CITY OF ST. AUGUSTINE CORRIDOR REVIEW COMMITTEE

**CITY OF ST. AUGUSTINE CORRIDOR REVIEW COMMITTEE
STAFF REPORT AND RECOMMENDATION
Prepared for the June 26, 2025 Meeting**

Application: HP2025-0047

Address: 241 W. King Street

Sheet Number A201

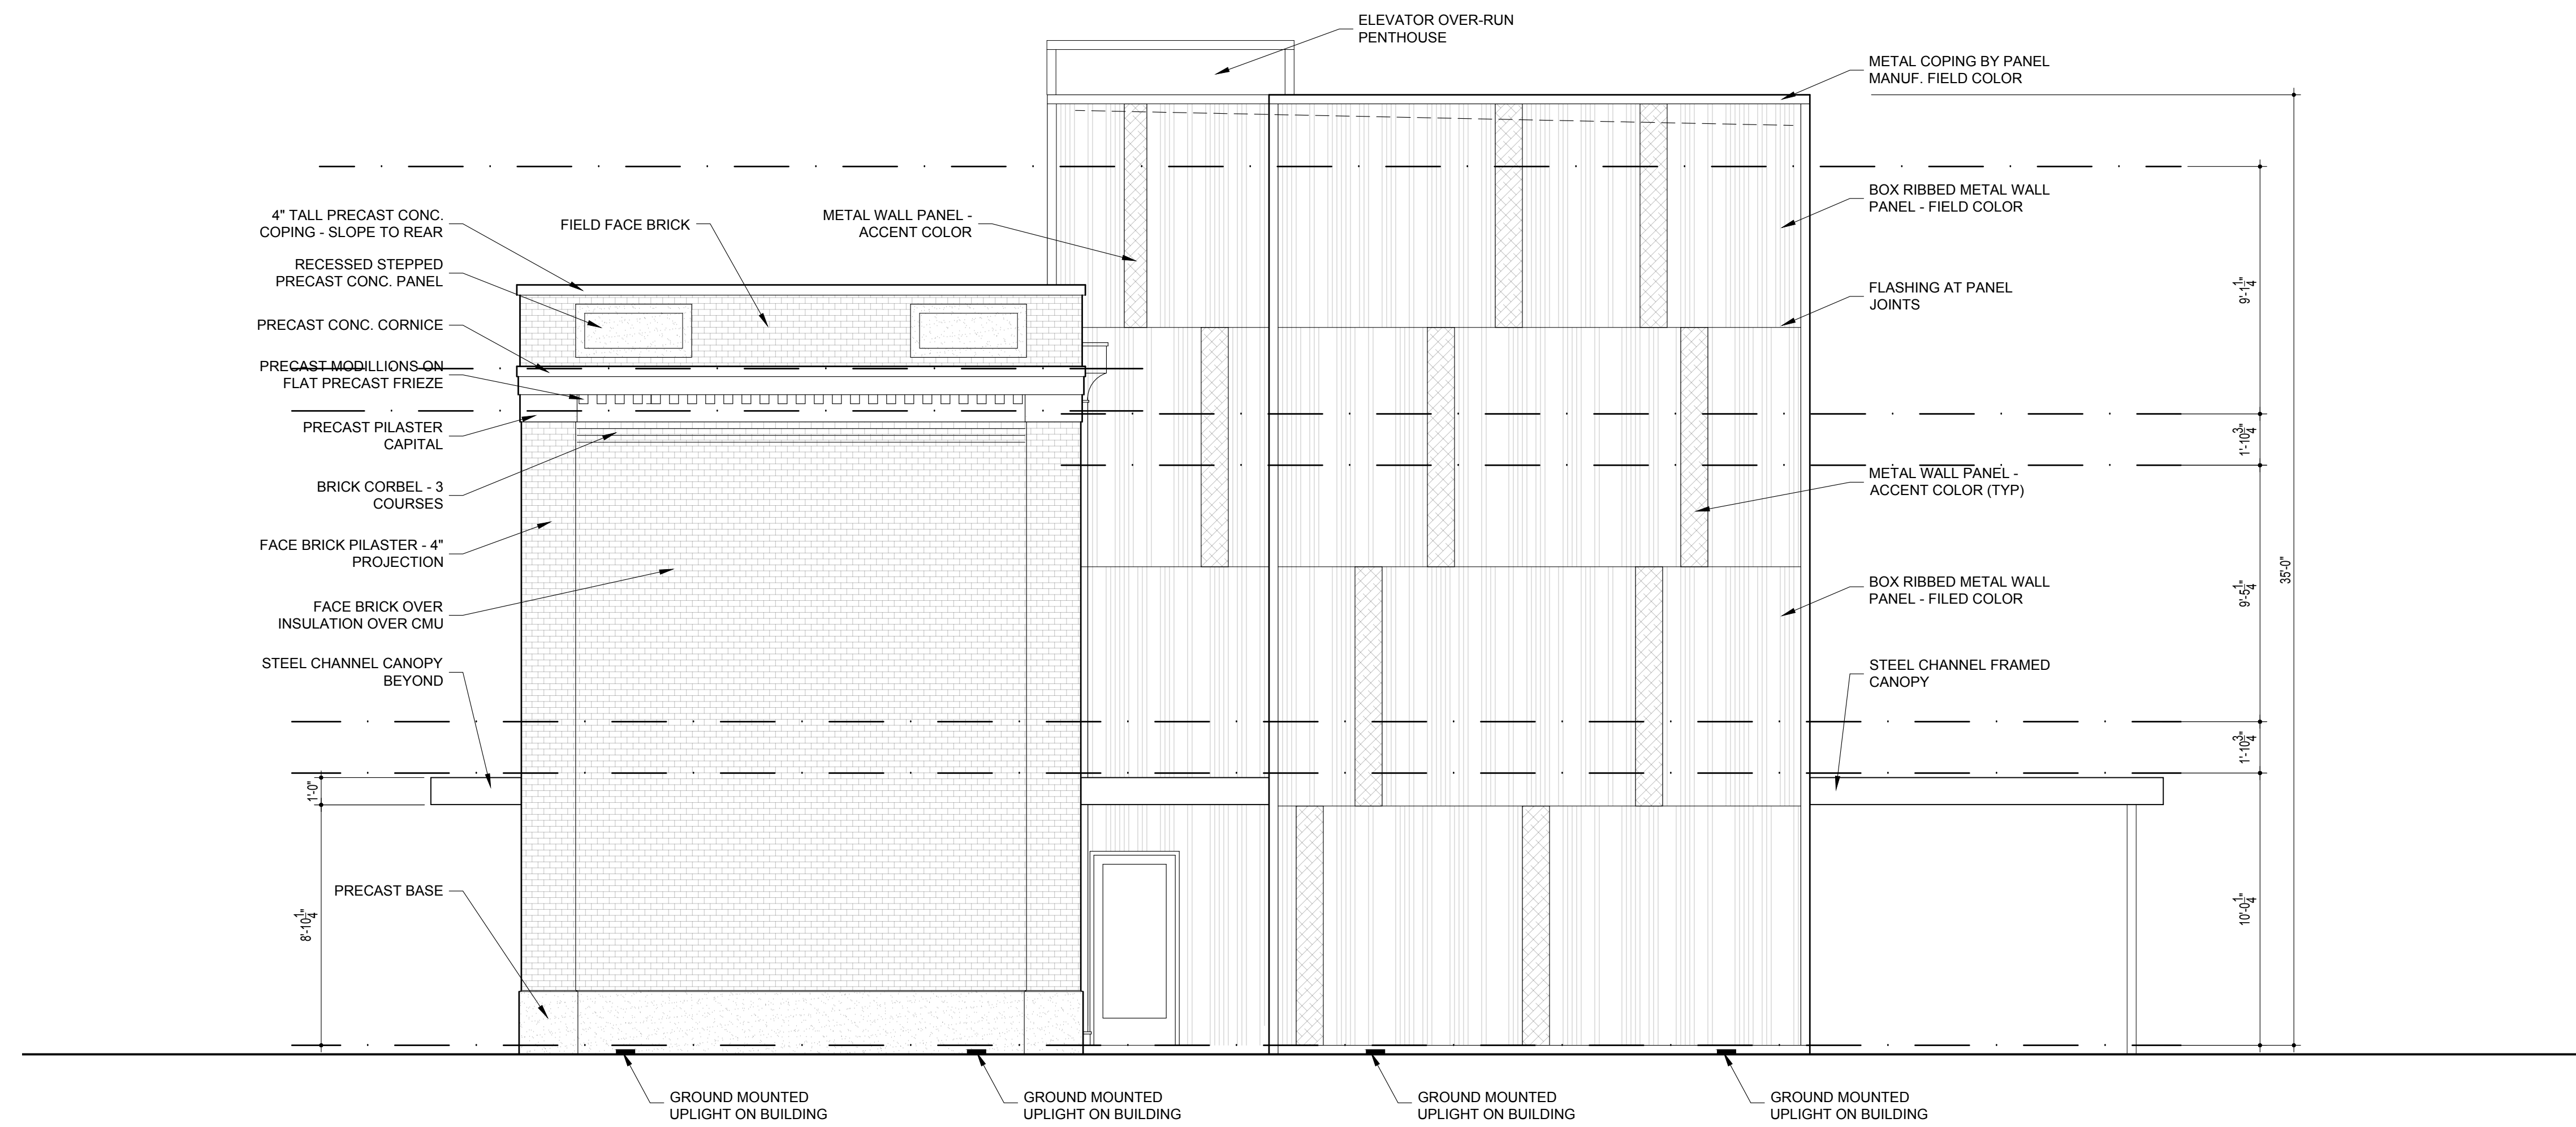
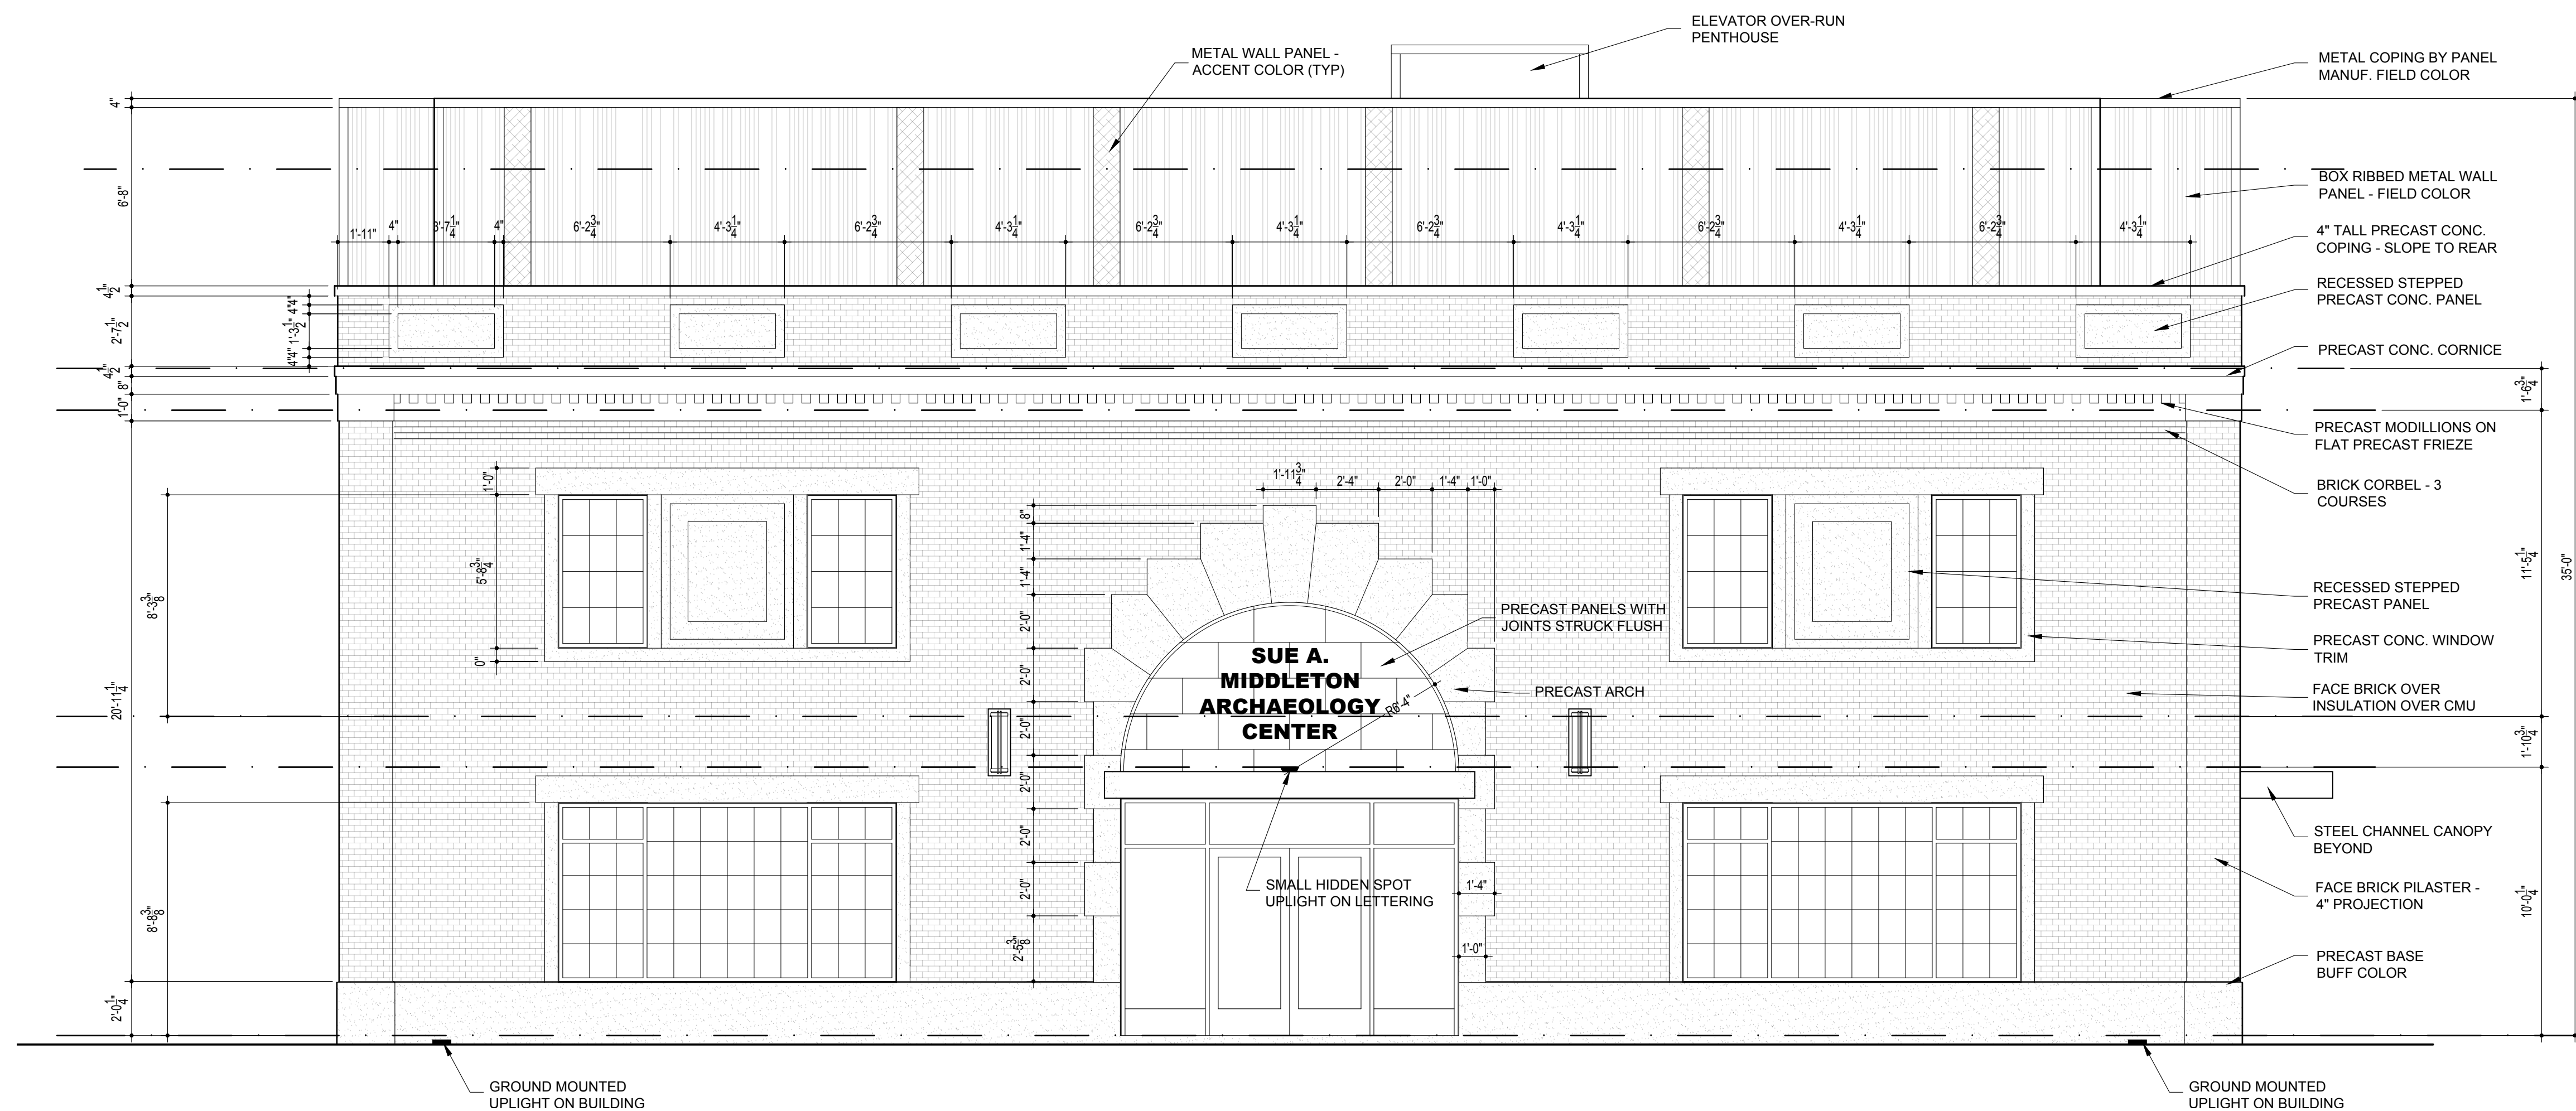
- a. Variance to the King Street Entry Corridor Design Standards to allow for less than the CRC approvable amount of glazing on the second floor W. King Street elevation. An increase in glazing of approximately 15sf would allow for CRC approval of the second story glazing as a Modification to the Standards (see glazing calculations attached).
